■ WILMINGTON TREATMENT CENTER [TRC Plan Review]

Initial Review Note

Original Sidewalk and Painted Crosswalks

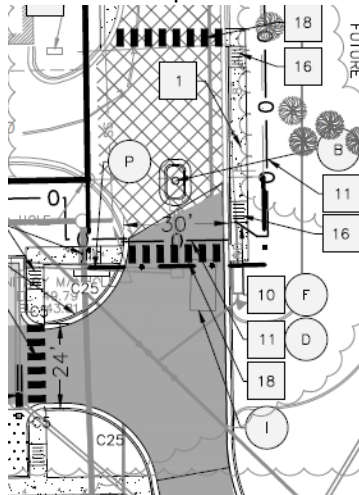
1. The proposed site plan does not show the sidewalk that was provided for the original Wilmington Treatment Center project and first two Dormitory Buildings. Sidewalk was approved for the North East portion of Reflections Loop and the connection to the Wilmington Fire Department drive aisle.

2. The site plans do not show the painted crosswalks approved for the original Wilmington Treatment Center and Dormitory Buildings. Please show the painted crosswalks on the plan.
3. Provide a sidewalk connection between the site and the sidewalk approved during the original project.
